THREE MILE ISLAND NUCLEAR STATION
UNIT NO. 1 EMERGENCY PLANNING IMPLEMENTING PROCEDURE 1004.8
CALLOUT OF ONSITE AND OFFSITE DUTY ROSTER PERSONNEL

Three Mile Island Nuclear Station Temporary Change Notice (TCN)

12. TCN No. 7-83-0217 (From TCN Log Index)

EPIP 1004.7

TCS AIRSAMPLE NOMOGRAPH

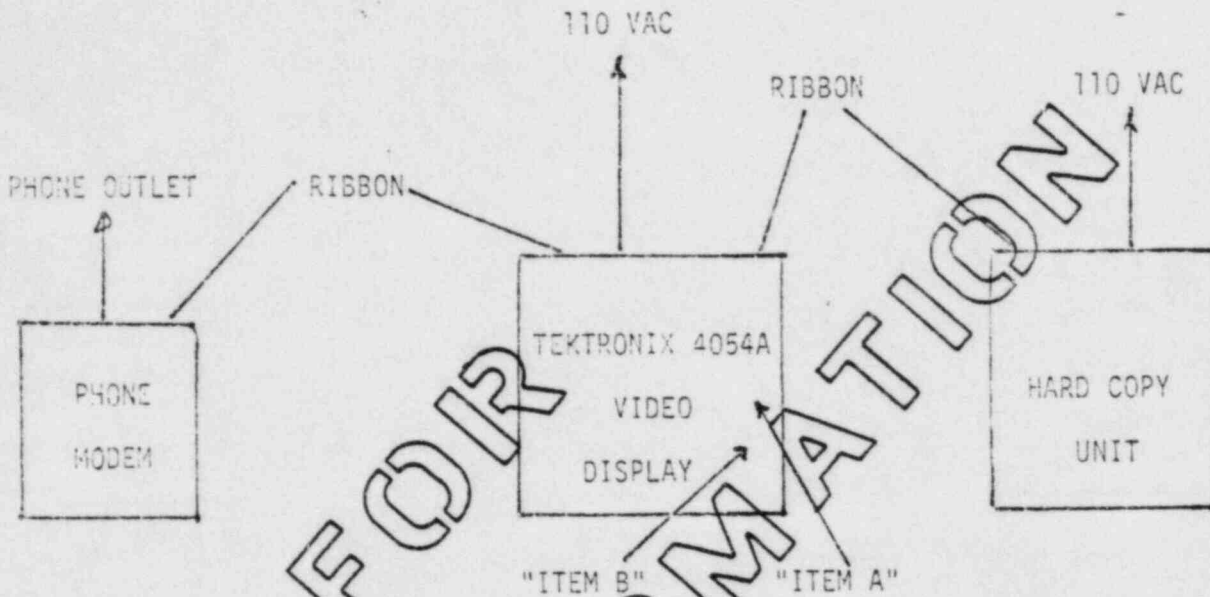
1. Replace present attachment VII with the "TCS Air Sample Nomograph".
2. Add to attachment VIII the material provided in sequential order. -

Align a straightedge with the Filter/Adsorber CPM (#1) and the time after shutdown that the sample was taken (#2). Read approx. Child Thyroid Dose commitment in mREM/HR where the straightedge intersects scale #3.
